Second Preliminary Consultation
MONTGOMERY COUNTY HISTORIC PRESERVATION COMMISSION
STAFF REPORT

Address:	7230 Spruce Ave., Takoma Park	Meeting Date:	2/22/2107
Resource:	Contributing Resource Takoma Park Historic District	Report Date:	2/15/2017
Applicant:	Aaron Kofner & Anat Shahr (Shawn Buehler, Architect)	Public Notice:	2/8/2017
Review:	2 nd Preliminary Consultation	Tax Credit:	N/A
Case Number:	N/A	Staff:	Michael Kyne
PROPOSAL: Addition and alterations

KOFNER-SHAHAR RENOVATION
7230 Spruce Avenue, Takoma Park, MD 20912

PROPOSED FRONT & SIDE ELEVATIONS
Scale: 1/8" = 1'-0"

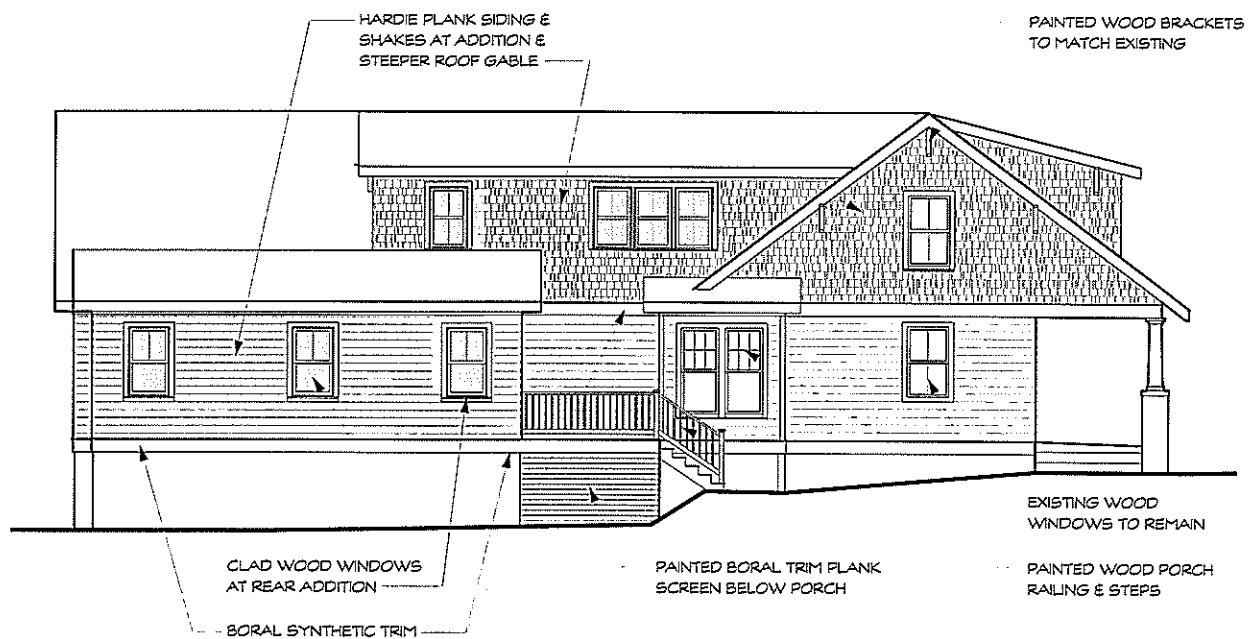
The applicants have reduced the slope of the roof of the proposed left side addition. As revised, the proposed left side addition will not engage the windows of the proposed shed dormer above, which was a previous concern of both staff and the Commission.

The proposed left side addition no longer includes a covered porch, allowing the projecting bay on the left side of the historic house to remain unobscured. The proposed left side addition also retains the approximate distance to the historic house as the existing left side addition, further reducing any impact that the addition might have on the projecting bay or left side elevation of the historic house.

Staff is generally supportive of the proposed revisions, finding that they are consistent with the *Guidelines*. Although the proposed left side addition will be visible from the public right-of-way and is not entirely at the rear, it will replace an existing addition in the same location and, by ensuring that the projecting bay is not impacted, will preserve the predominant architectural features of the resource.

The applicants propose to construct two new shed dormers (one on each side of the proposed new rear addition), which will return to the rear roof plane of the historic house. The shed dormer on the right (as viewed from the front) will be larger than that on the left, providing some of the interior space that would have been provided by the second-floor of the previously proposed mudroom.

The ridge of each dormer, as well as that of the proposed rear addition, will converge at the same approximate height as the historic ridgeline. Staff is generally supportive of the proposed shed dormer additions, finding that, in accordance with the *Guidelines*, they are at the rear of the property and generally consistent with the predominant architectural style of the subject property.

2 PROPOSED SIDE ELEVATION
Scale: 1/8" = 1'-0"

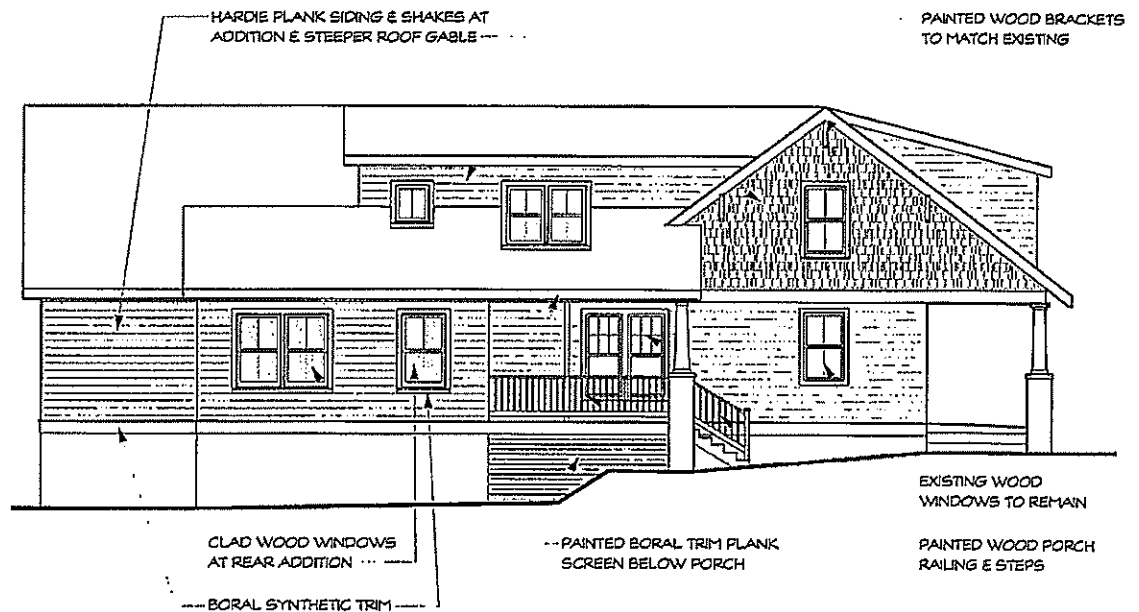
17 MR. ARKIN: I'm generally in agreement with many
18 of the comments made by the previous Commissioners, but I
19 find myself staring at the drawing on Circle 17 at the top.
20 And not really understanding how the roof over the mudroom
21 and the garage will work. I do agree with the comment that
22 was made by the prior speaker, or one of the prior speakers,
23 that I think a better solution would be to detach the
24 garage. And one advantage to that is that we would probably
25 look at a detached garage with less intensity than we look

1 at it while it's attached. If you did that, and if you
2 could somehow move the bedroom that's partially over the
3 garage back some, I think you'd have more of a
4 differentiation between the old and the new, if I'm seeing,
5 if I'm understanding this drawing correctly.
